Office Action Summary

10/774,264

BAYER ET AL.

DETAILED ACTION

As for Claim 1, EP 0200924 teaches of a arrangement/link construction for a crystal pendant, the arrangement (Fig. 23, see figure below) comprising:

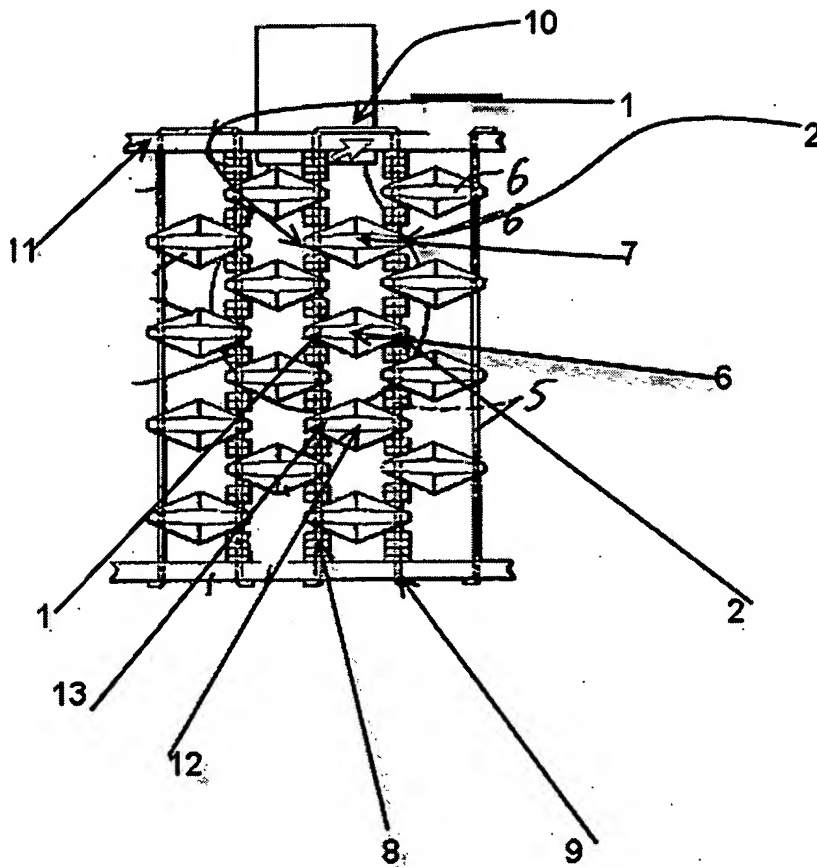
[5] Claims 1, 3-4, 10, 12-14, 23-25, 50, 54-58, 63-64 are rejected under 35 U.S.C. 102(b) as clearly anticipated by EP 0200924, because the invention was patented or described in a printed publication in this or a foreign country, or in public use or on sale in this country more than one (1) year prior to the application for patent in the United States.

- a first ornament (6) having at most a first aperture (1) and a second aperture (2);
- a second ornament (7) having at most a first aperture (1) and a second aperture (2); and
- a first connector wire (8) (page 14, line 23, "...of a generally metallic wire forming...") having a first end inserted into and bent to engage the first aperture (1) of the first ornament (6) and a second end inserted into and bent to engage the first aperture (1) of the second ornament (7); and

- a second connector wire (9) (page 14, line 23, "...of a generally metallic wire forming...") having a first end inserted into and bent to engage the second aperture (2) of the first ornament (6) and a second end inserted into and bent to engage the second aperture (2) of the second ornament (7);

whereby the second aperture (2) of the first ornament (6) is laterally disposed from the first aperture (1) of the first ornament (6).

As for Claim 23, EP 0200924 teaches of a arrangement/link construction for a crystal pendant, the arrangement (Fig. 23, see figure above) comprising:

at least one hook (10) having a first end (8) inserted into and bent to engage the first aperture (1) of the ornament (6 or 7), a second end (9) inserted into and bent to engage the second aperture (2) of the ornament (6 or 7), and a loop (below 10) positioned between the first end (8) and the second end (9), the loop (below 10) [adapted to be] hung from a support (11);

As for Claim 54, EP 0200924 teaches of an arrangement for connecting decorative ornaments the arrangement (Fig. 23, see figure above) comprising:

- at least one continuous connector (8) adapted to be inserted into and bent to engage an aperture of at least the first ornament (6), the second ornament (7), and the third ornament (12),

persuasive. The prior art of EP 0200924 is still considered by the examiner as being anticipatory towards the above amended claims. The examiner still maintains that in the broadest reasonable interpretation possible, the wire connectors can and are considered as being inserted into and bent to engage the apertures of the various ornaments. The applicant states in the remarks that the wire 5 does not engage each aperture in ornament as claimed. The examiner disagrees. The claim never states at what location the wire is bent so that the wire is engaged into the aperture of the ornaments. Is the wire bent before or while inside the aperture for example? Further clarification with respect to the claim language may help to properly differentiate this possibly distinct feature in the instant invention from that of Fig. 23 of EP 0200924.

In addition, the examiner also would like to note that a further difference between the prior art of EP 0200924 and the instant invention may reside in the fact that the first and second ends of the connectors terminate (in least in one embodiment) at or just around the apertures of the ornament (or right after being bent), not progressing to other multiple ornaments.
